Subject: Palo Verde Nuclear Generating Station (PVNGS)
Units 1, 2, and 3
Pressurizer Safety Valves
Docket Nos. STN 50-528(License No. NPF-34)/529/530
File: 85-056-26; G.1.01.10

PVNGS RESPONSE TO NRC REQUEST FOR ADDITIONAL INFORMATION

PALO VERDE SAFETY VALVES

FIGURE 1
COMPARISON OF THE FWLB WITH LOP
AND THE LOCV TRANSIENT REGARDING PRESSURIZER LEVEL

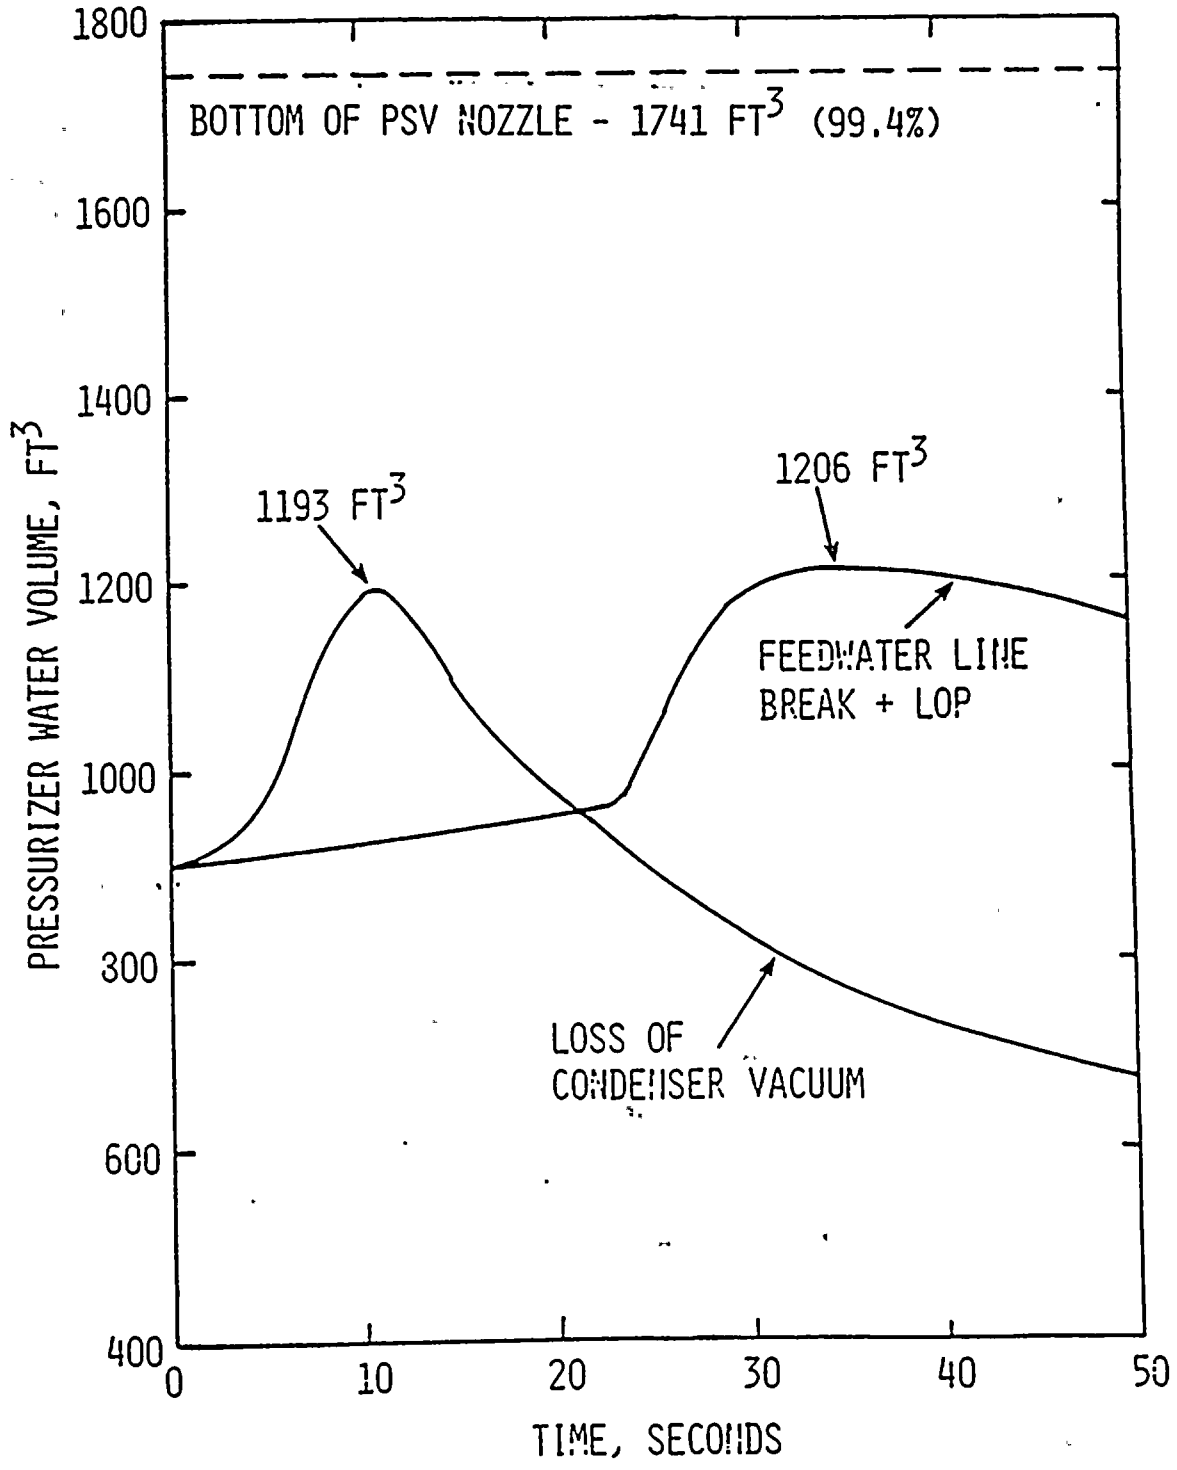
A postulated FWLB may lead to the most limiting transient of RCS temperature and pressurizer water level. Provide the results of an FWLB analysis using Palo Verde plant specific parameters (e.g. AFWS, HPSI, LPSI, Primary and Secondary Safety Valves). Provide the transient curve to show the temporal behavior of pressurizer water level, RCS subcooling margin, RCS pressure and DNBR.

In order to determine which of these two transients (FWLB or LOCV) result in the greatest increase in pressurizer water level, the NSSS responses to these events were simulated using all the PVNGS specific parameters (e.g. AFW, HPSI, LPSI, Primary and Secondary safety valves) and the CESEC III code. These transients were analyzed with an equivalent set of initial conditions which are provided in Table 1. Figure 1 provides the pressurizer water volume results for the LOCV and FWLB transients. As is shown, the maximum pressurizer water volume for the FWLB transient with the loss of offsite power (LOP) is 1206 ft³ and for the LOCV transient, 1193 ft³.
